FC9112  
/A  
/B

Philips Domestic Appliances and Personal Care

# Service Manual

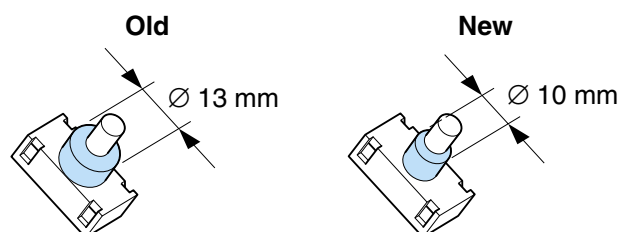
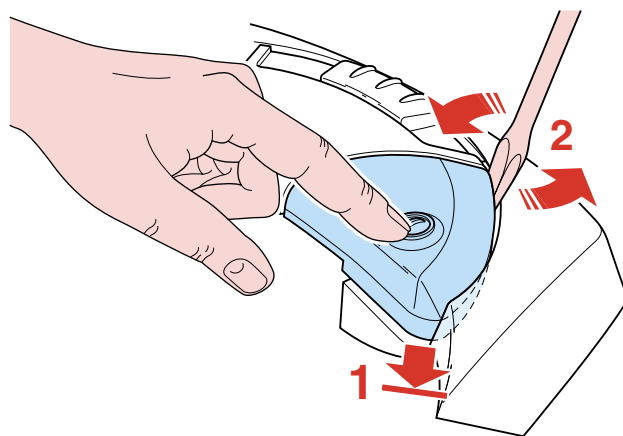
- Due to introduction of a **new switch** (item 11) 0320 onwards, which is not interchangeable with the old switch soldered on the PCB (item 12).
- The switch lever assy (item 11a) is also modified.

To recognize the switches:

To replace the knobs:

New spares are:

11	Switch soldered version	- 4322 006 50600
11a	Switch lever assy	- 4322 009 08980
parts of 15	Switch and Cord winder knob	- 4322 009 09000
